ADDENDUM 01, DELTA 01

DATE 01.30.2026

PROJECT: Santa Rosa Freestanding Emergency Room

ARCHITECT'S PROJECT NUMBER:
225014.00

TITLE

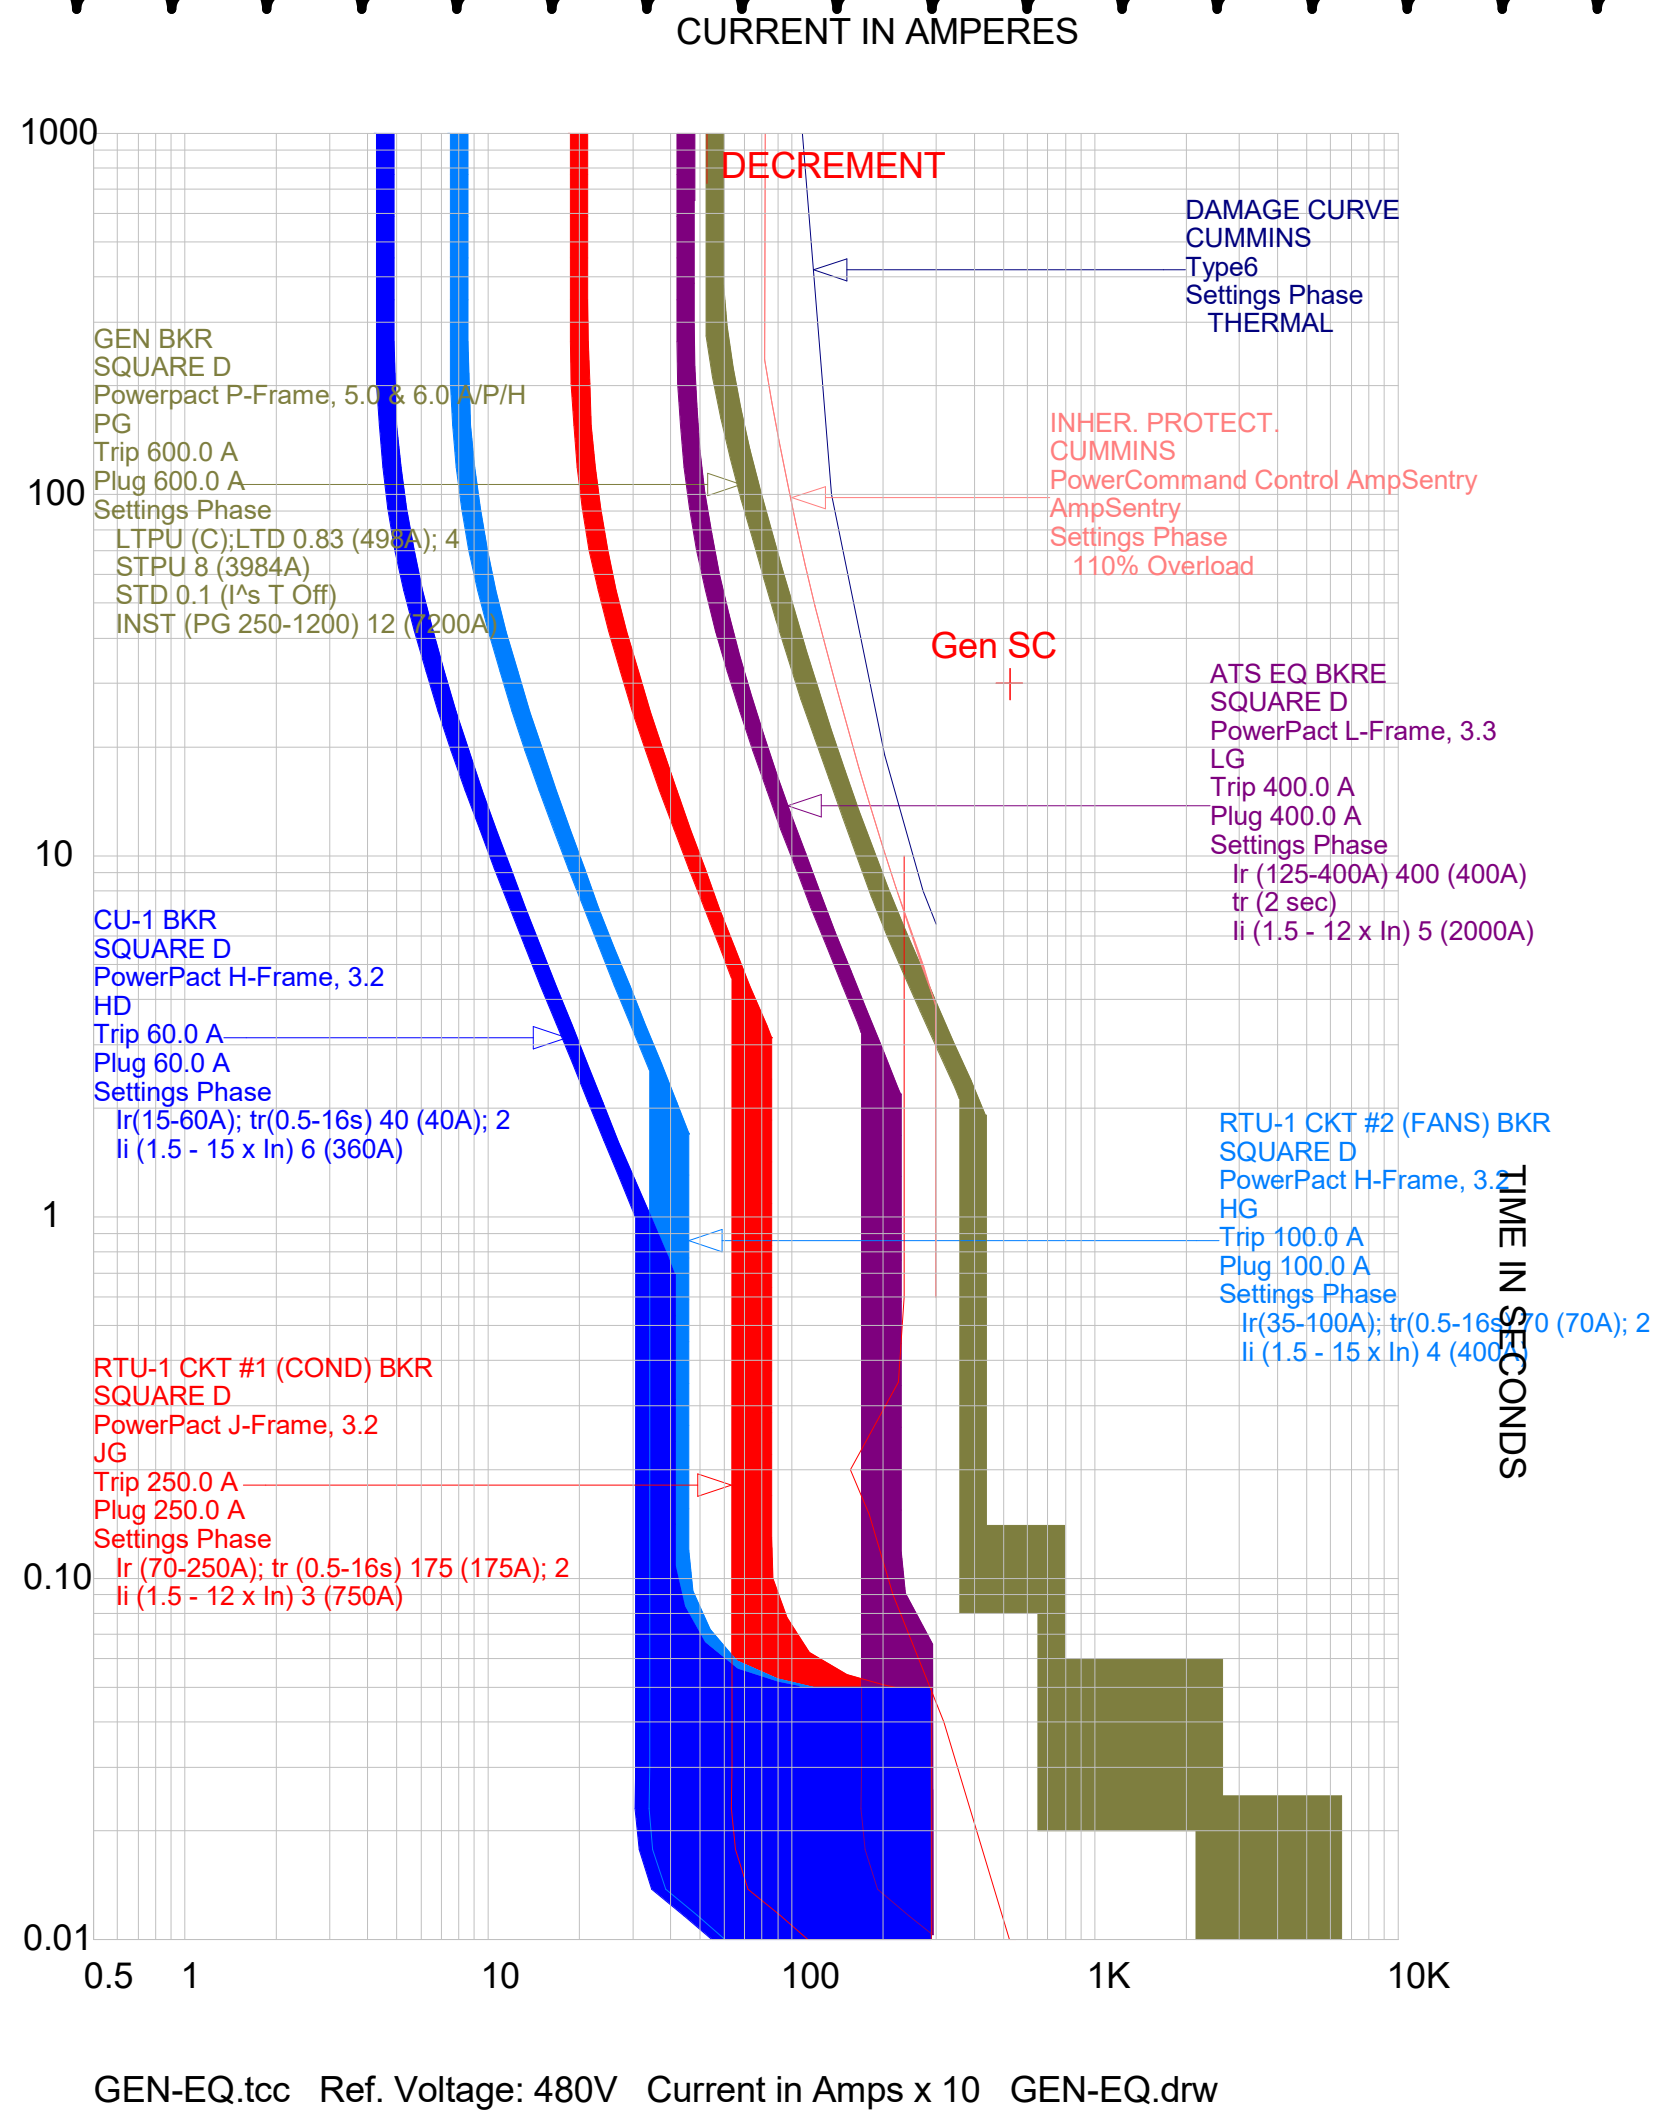
1. Revised the breaker curves to comply with AHCA comments.
